Sheet: /
File: icesugar-nano-carrier.kicad_sch

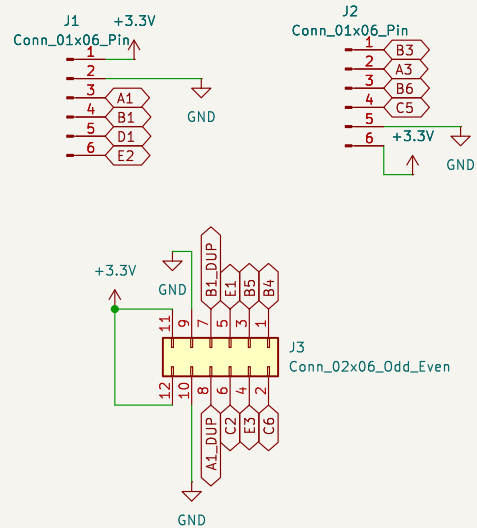
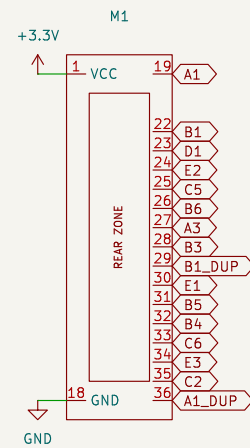
Why on earth are A1 and B1 connected to two different PMODs, when there are unused pins on the FPGA?
